Technical Service Bulletin

01 MIL on, DTC P243600 and/or P243700 stored in ECM

01 19 97 2049142/4 January 2, 2019. Supersedes Technical Service Bulletin Group 01 number 18-65 dated April 19, 2018 for reasons listed below.

Model(s)	Year	VIN Range	Vehicle-Specific Equipment
R8, R8 Spyder	2017	000001 - 905000	Not Applicable

Figure 1. Replace the sender.

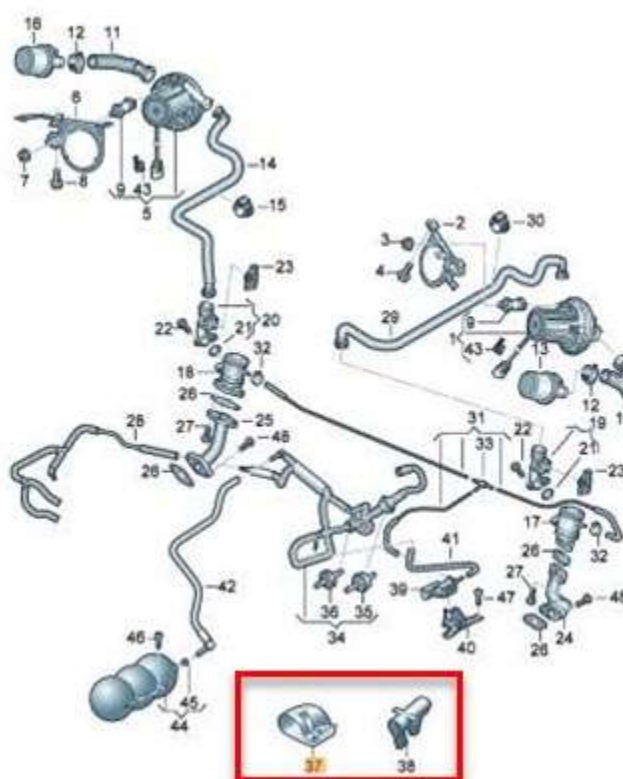
2. Then add the insulation (Figure 1, number 37 and 38) on the pressure sensor Bank 2.

At the end of the repair the pressure sensor and the combination valve should have the insulation on both banks (Figure 1, number 37 and 38). See Figure 2 for an example of installed insulation.
